Reference: STI AF-SBC-97-004

Special Technical Instruction - Possible cracking to engine mounting plate to limited number of later production aircraft.

17.11.97
 STI-AF-SBC-97-004

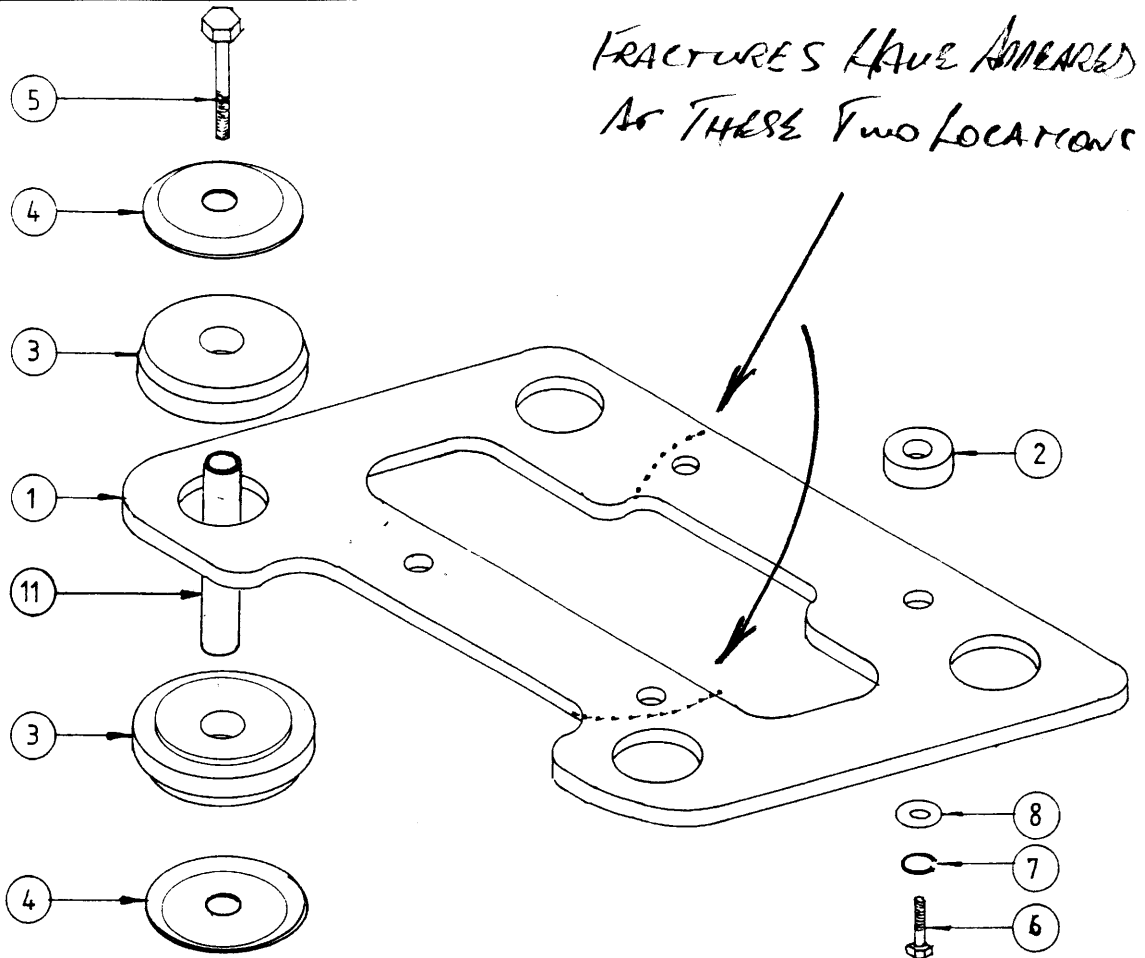
Problem: Two separate incidents have been reported to this factory of high hour training aircraft found to have fractures appear in the aluminium engine mounting plate. Our history file would indicate this problem is limited to later build aircraft using the red polyurethane mount rubbers.

Fracture initiates from contact point of metric 10 bolt washer and proceeds forward and aft on the centre section of the plate.

Procedure: Inspect existing plate for evidence of fracturing at or around centre four metric bolt washer contact area, particularly left front, right rear.

Inspection can be carried out in-situ by firstly cleaning the plate area with a solvent or detergent then eye ball inspection from all sides to determine if any fractures are present. If no fracturing is found please carry out regular inspection during daily inspection, pre-flight inspection and at least every 20 hour of engine operation.

The plate is not difficult to change and requires only the exhaust mount rubber strip, four metric 10 engine to plate bolts and the four plate to frame bolts to be removed. The engine can then be lifted sufficiently to slide the old plate out and the new one in.

Ensure plate is installed with engine offset to the left of airframe centre when viewed from the rear, looking toward the propeller.

The four metric 10 bolts are secured with Loctite 222 and torqued to 40 nm (30 Lbf ft) then lockwired. The four 5/16" bolts and nuts securing the poly mount to the frame are torqued to 14 nm (10 lbf ft).

The four 3/16" bolts securing the exhaust rubber strip are lightly tensioned.
